Conceptual Design

Wyoming Blvd Pedestrian Study
Casper, WY

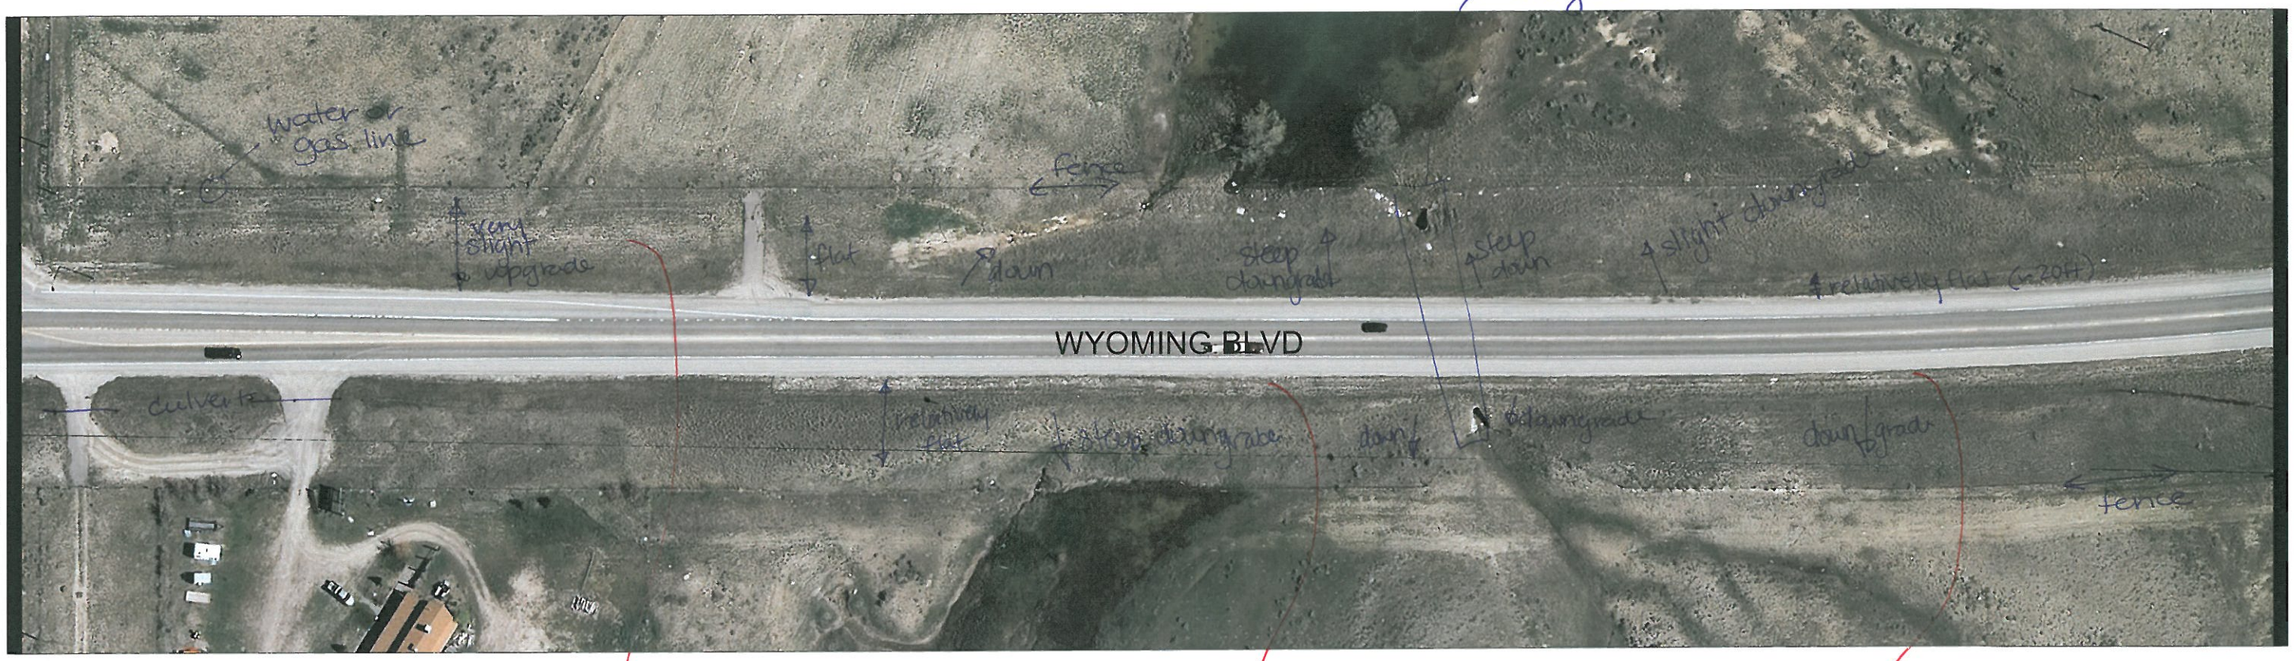
Consider trail along fence

Need to stay with 10-15 ft from edge of road

Keep trail attached here

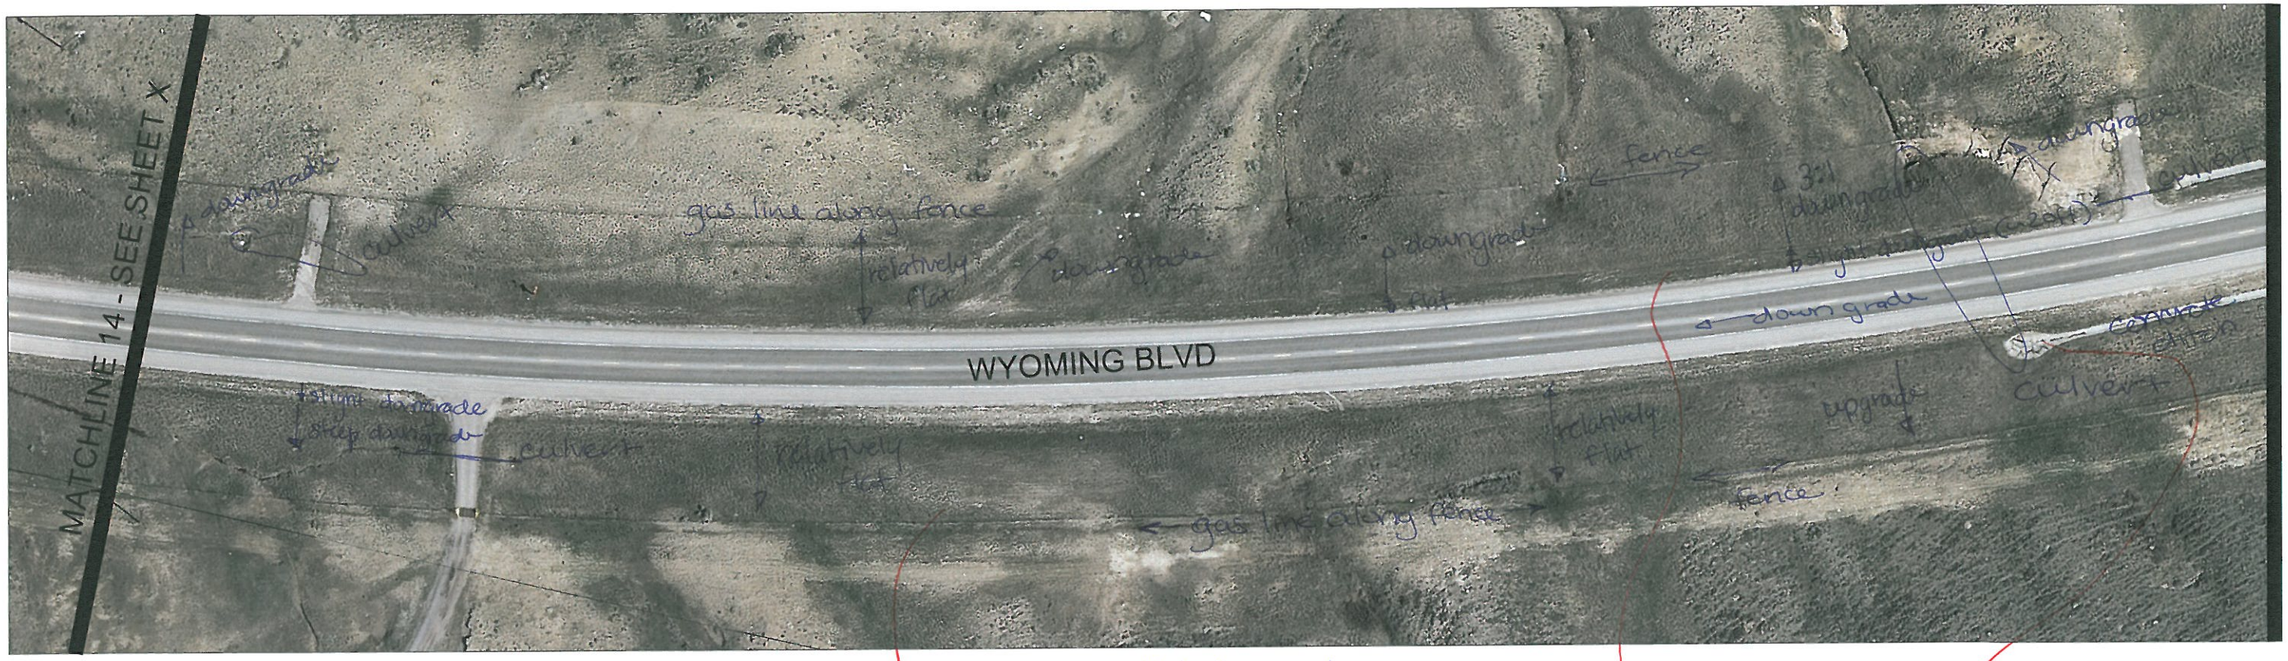
Consider running trail along fence

Keep trail near road

Consider piping ditch or combine w/ trail

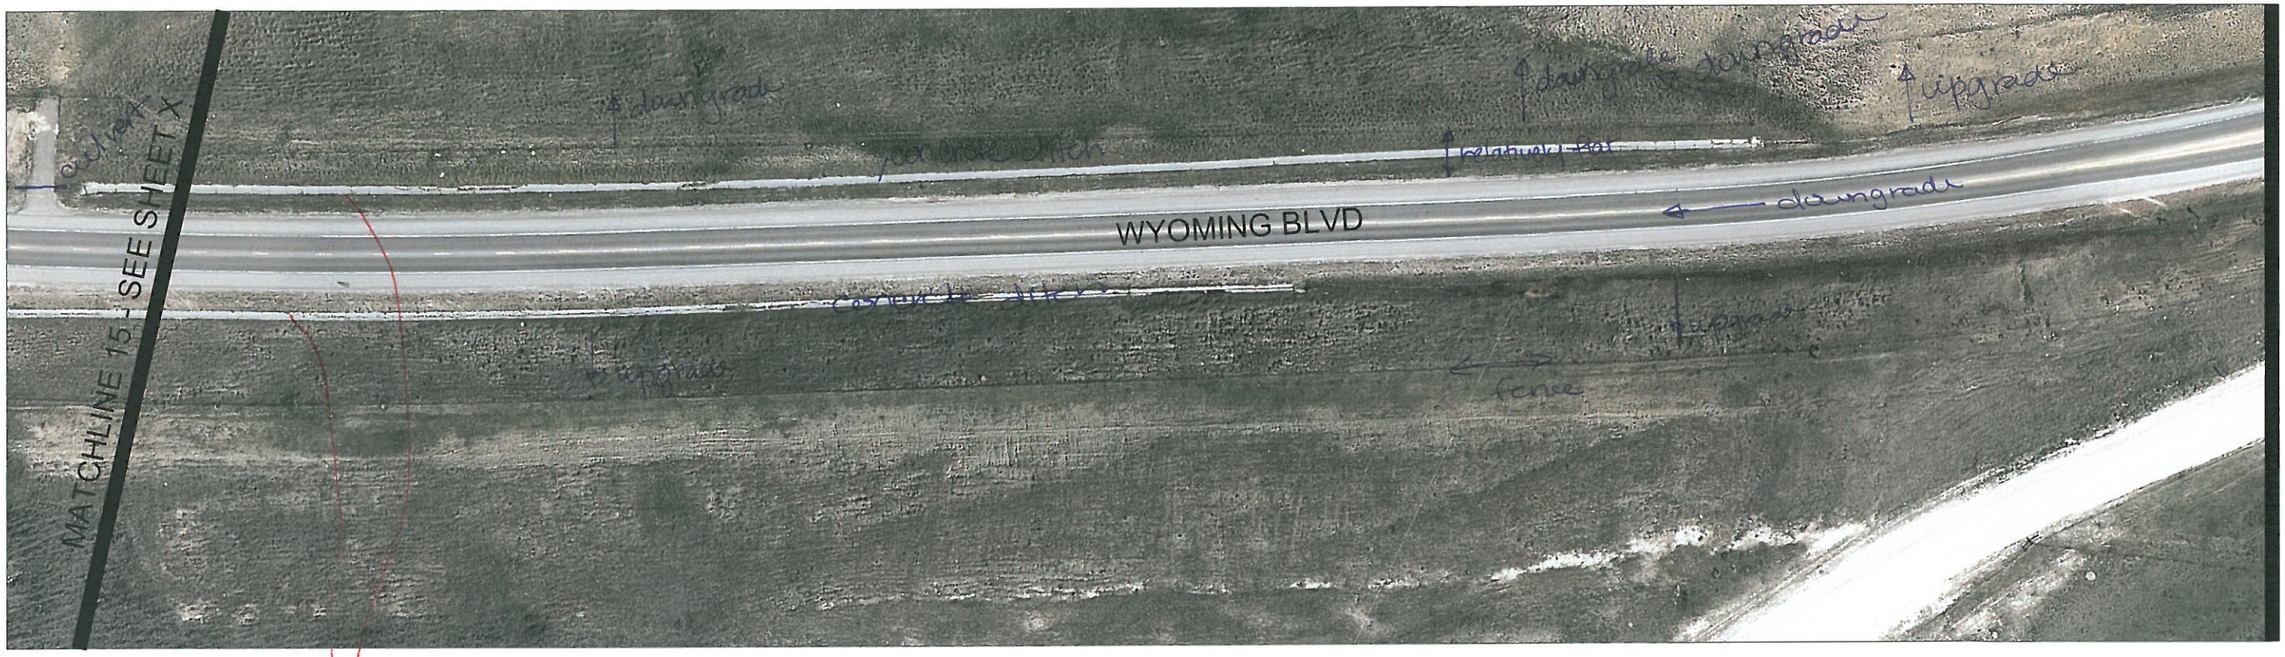
Consider removing concrete ditch and reconstructing w/ trail

Consider placing the trail in the middle of ROW

Bring trail closer to the roadway

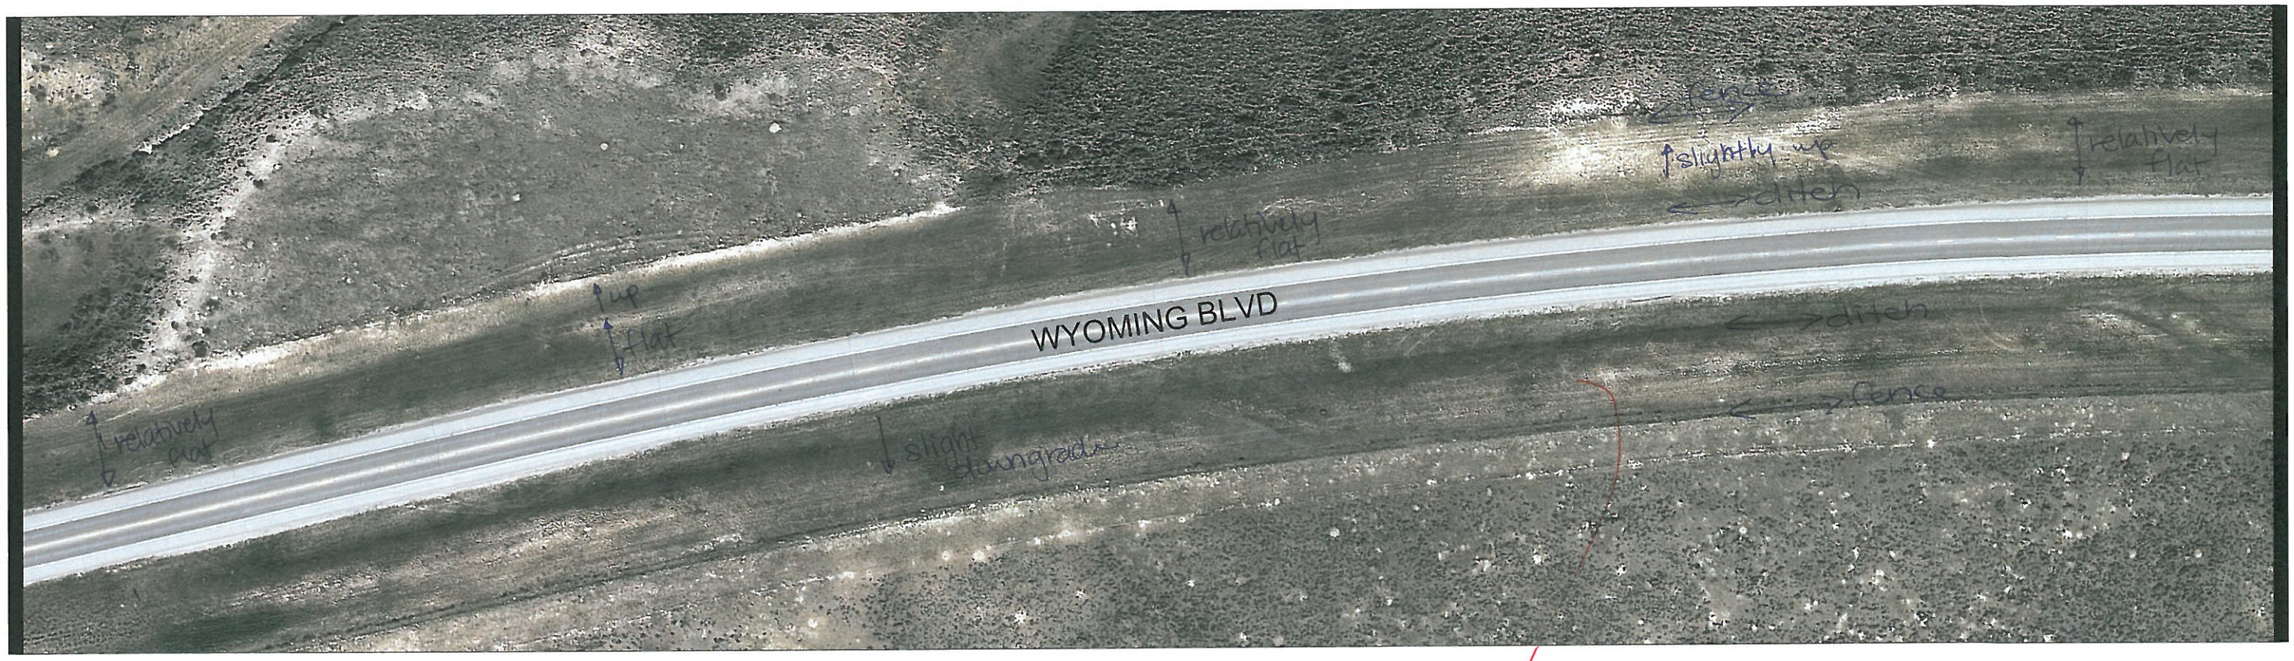
Consider placing trail in the middle of ROW or along fence.

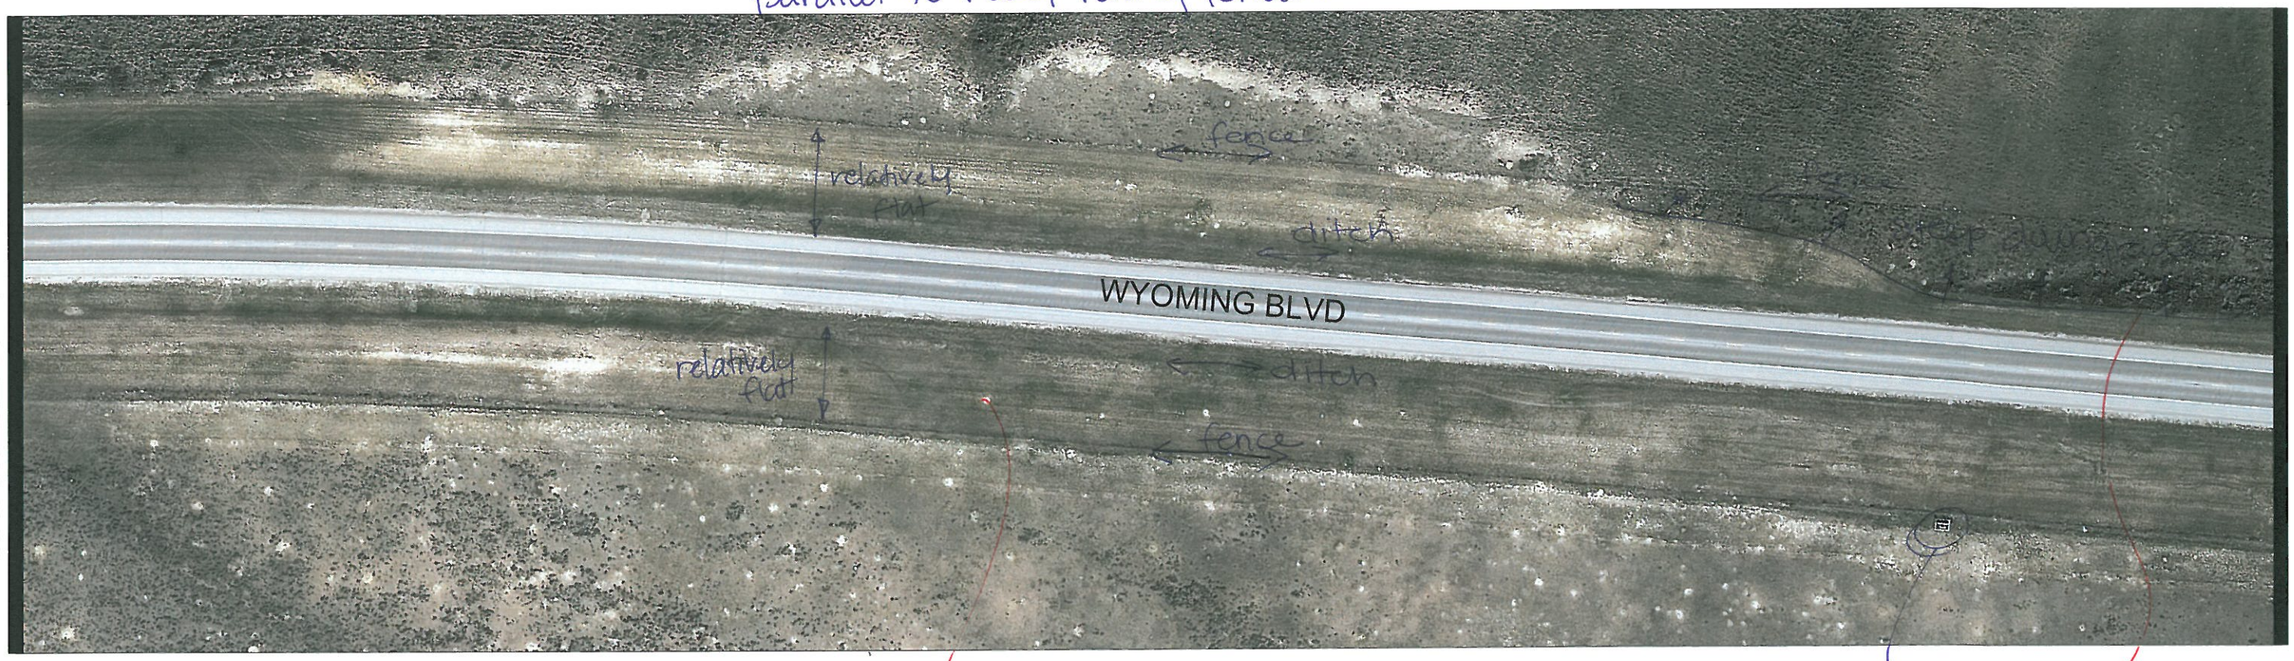
Keep trail near road

Consider placing trail in the middle of ROW

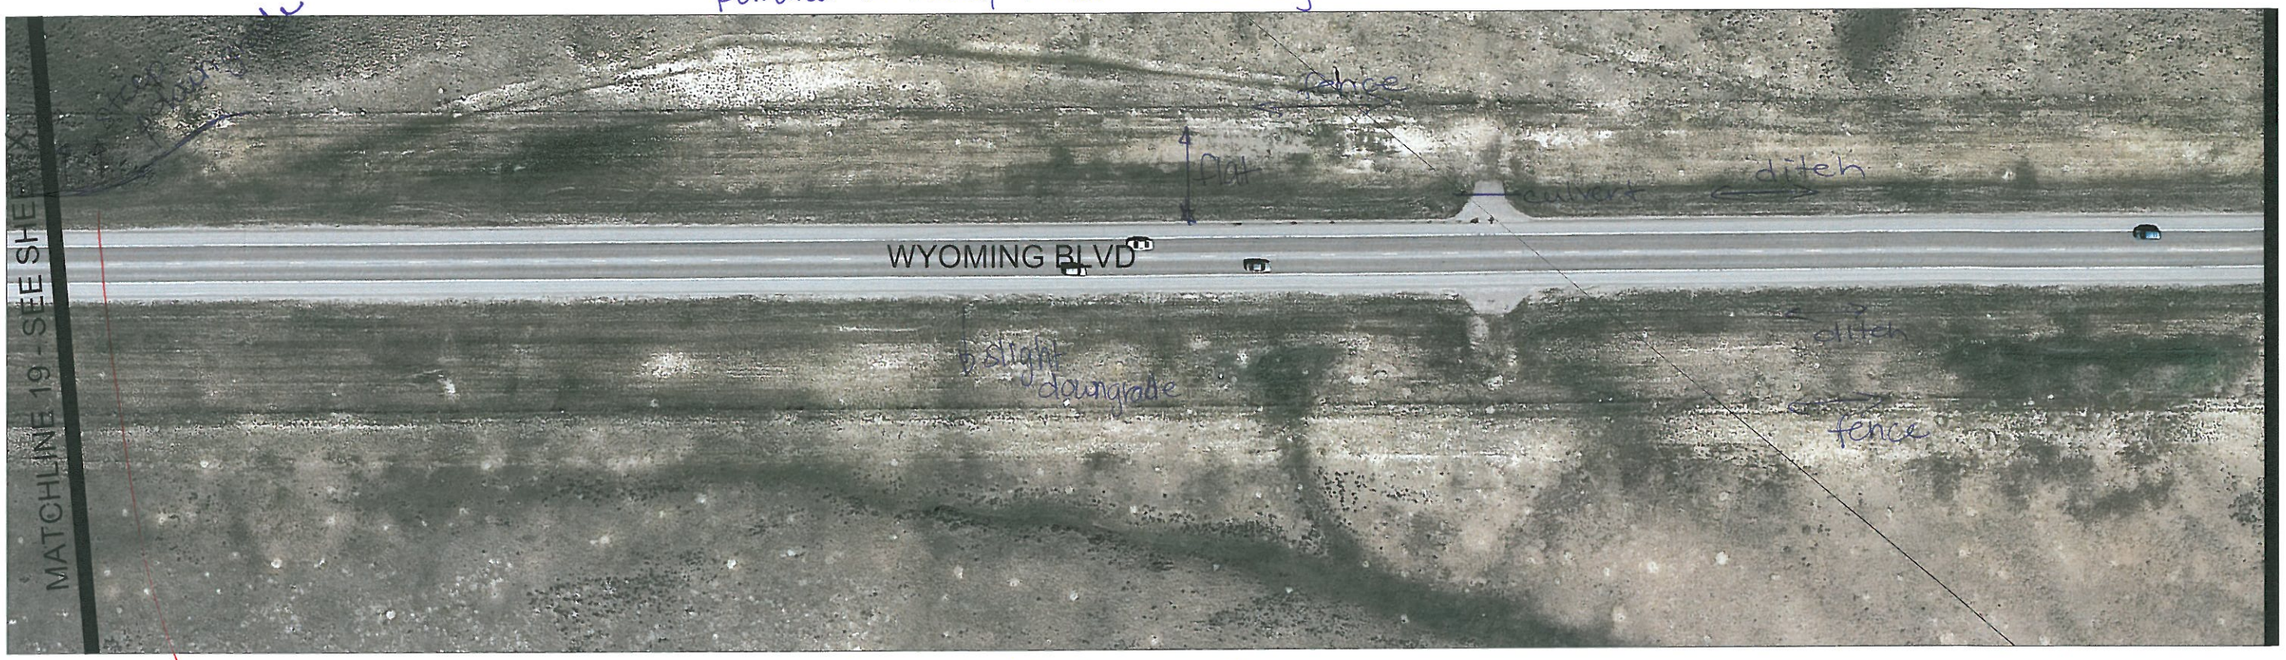
Bring trail back to road

Consider placing trail along fence or ditch.

Both sides, consider placing trail along road (attached) or bridge over ditch

- May need minimal grading to level trail

Consider placing trail along ditch or fence

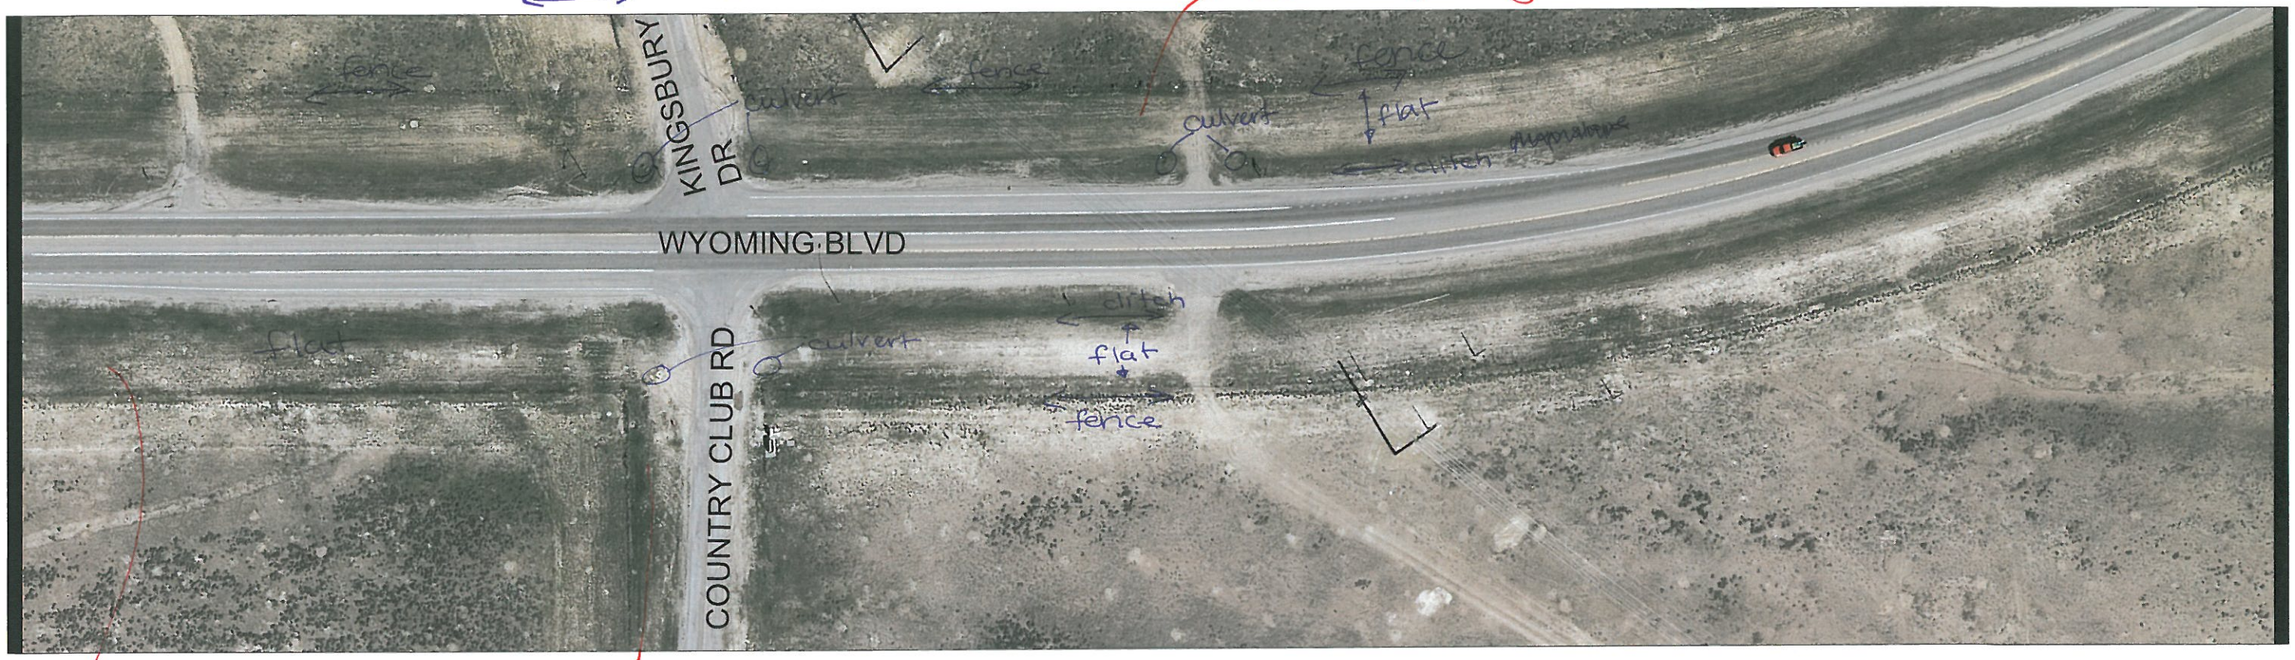
Consider placing trail along ditch or fence

Consider bringing trail back to intersection corner
